DEVELOPMENT APPLICATION ASSESSMENT REPORT

Application Number:	DA2021/1190
----------------------------	-------------

Responsible Officer:	Catriona Shirley
Land to be developed (Address):	Lot 19 DP 758016, 18 Libya Crescent ALLAMBIE HEIGHTS NSW 2100
Proposed Development:	Alterations and additions to a Dwelling House
Zoning:	Warringah LEP2011 - Land zoned R2 Low Density Residential
Development Permissible:	Yes
Existing Use Rights:	No
Consent Authority:	Northern Beaches Council
Land and Environment Court Action:	No
Owner:	Matthew John Blackband Nicole Lee Blackband
Applicant:	Cape Cod Australia Pty Ltd

Figure 1: Wall height non-compliance shown in pink.

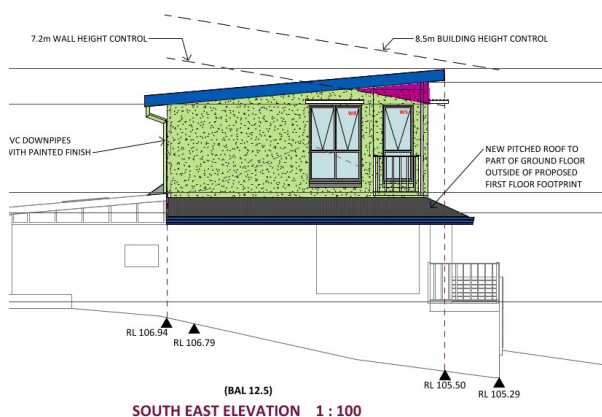
Part B1 of the WDCP 2011 prescribes a 7.2m high wall height control for singular planar elements of a dwelling. The proposal breaches the wall height control by up to 8.3% to a total height of 5.8m - 7.8m above existing ground level.

The non-complying sections of wall are influenced by the existing natural ground level of the site and slope.

The portion of the building which exceeds the wall height control is located to the front of the first floor and does not cause any unacceptable impact on neighbours. No unreasonable amenity, overshadowing, or building bulk impacts will result from the non-compliant wall height with regard to adjoining properties. The submitted shadow diagrams demonstrate compliance for 21 June, 9am to 3pm period for adjacent private open space.

Figure 2: Building Height Envelope non-compliance shown in pink.

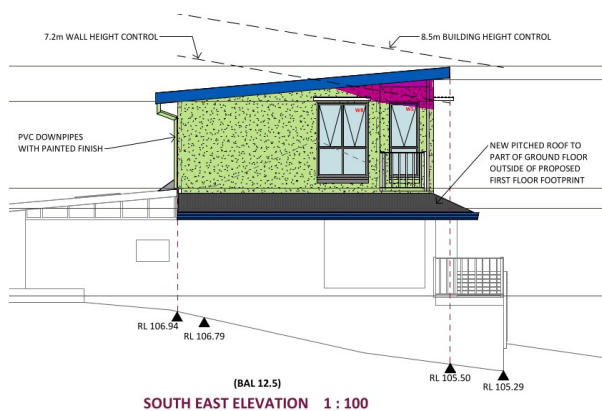
Part B3 of the WDCP 2011 prescribes a 4m building envelope to the elevations of a house. To the western elevation of the subject dwelling, the first floor extension encroaches this envelope for the entire depth of the building at a height up to 0.7m, see Figure 2 below.

The proposed development generally complies with the built form controls prescribed by Part B of the WDCP 2011, with the exception of the wall height and envelope breach on the western elevation. Given the general compliance of the development, which in part exceeds all setback requirements, and given the modest scale of the first floor addition and the complementary architecture proposed, it is not considered that the development will be of a visually dominant height and bulk than what currently exists. See Photo 1 below.
